Project	<b>IEEE 802.16 Broadband Wireless Access Working Group</b> < <a href="http://ieee802.org/16">http://ieee802.org/16</a> >	
Title	<b>OFDM DL preamble enhancement for Zero IF receivers</b>	
Date Submitted	<b>2004-04-28</b>	
Source(s)	Bogdan Franovici, Lingjie Li Redline Communications Inc. 302 Town Center Blvd. Markham, ON, L3R 0E8	Voice: ++1-(905) 479 8344 Fax: ++1-(905) 479 5331 <a href="mailto:bfranovici@redlinecommunications.com">mailto:bfranovici@redlinecommunications.com</a>
Re:	802.16-REVd/D4 Sponsor Ballot	
Abstract	This contribution introduces a change to the 802.16 OFDM DL preamble which will enable the deployment of low cost Direct Conversion receivers for the subscribers where cost is critical.	
Purpose	Adopt into P802.16-REVd/D5 draft.	
Notice	This document has been prepared to assist IEEE 802.16. It is offered as a basis for discussion and is not binding on the contributing individual(s) or organization(s). The material in this document is subject to change in form and content after further study. The contributor(s) reserve(s) the right to add, amend or withdraw material contained herein.

# OFDM DL preamble enhancement for Zero IF receivers

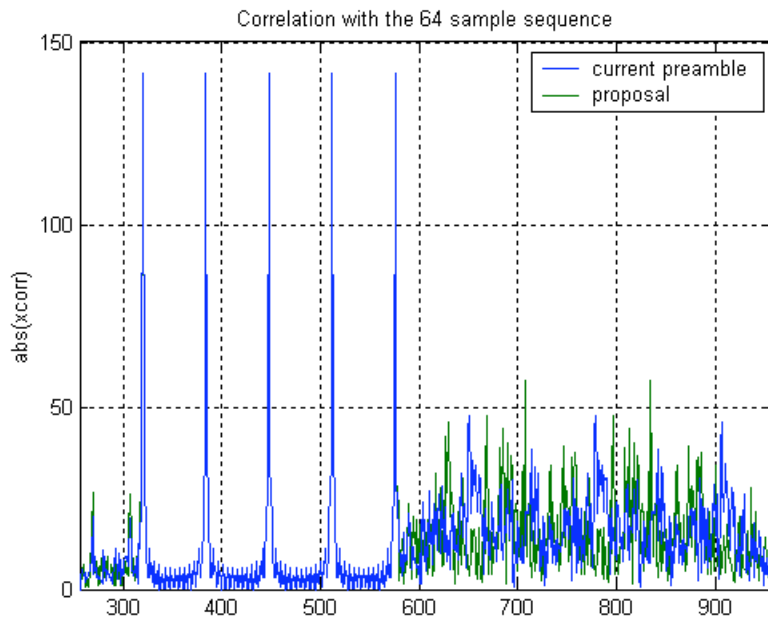
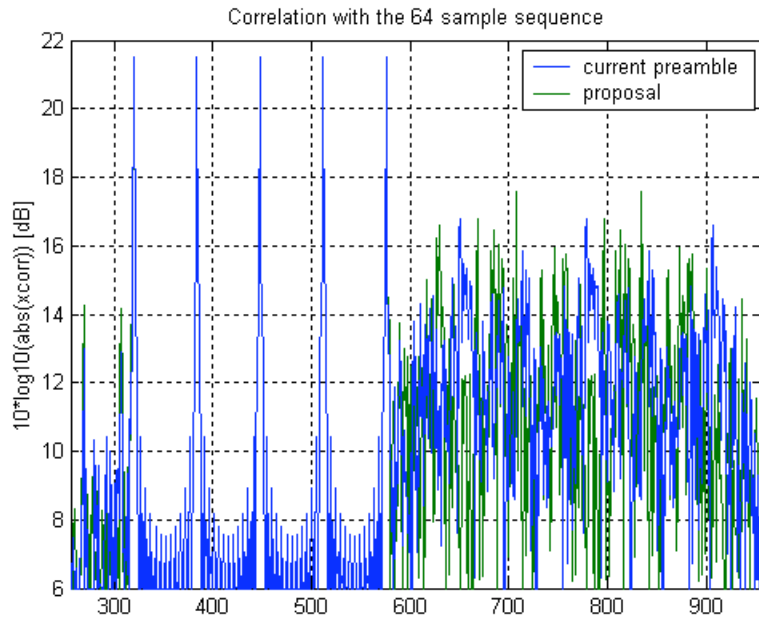
Section 8.3.3.6, page 419, lines 55-57, replace:

$$P_{4 \times 64}(k) = \begin{cases} \sqrt{2} \cdot \sqrt{2} \cdot \text{conj}(P_{ALL}(k)) & k_{\text{mod}4} = 0 \\ 0 & k_{\text{mod}4} \neq 0 \end{cases}$$

The following figures show the correlation between the long preamble and the 64 sample sequence (1/4 of  $P_{4 \times 64}$ ).

There is 0.8dB loss for the proposed preamble w.r.t. the current preamble.

$$P_{4 \times 64}(k) = \begin{cases} \text{sgn}(k) \cdot \sqrt{2} \cdot (-1)^{\text{floor}((|k|-4)/20)} \cdot P_{EVEN}(-k) & k_{\text{mod}4} = 0 \\ 0 & k_{\text{mod}4} \neq 0 \end{cases}$$

Move  $P_{4 \times 64}$  definition after  $P_{EVEN}$  definition.
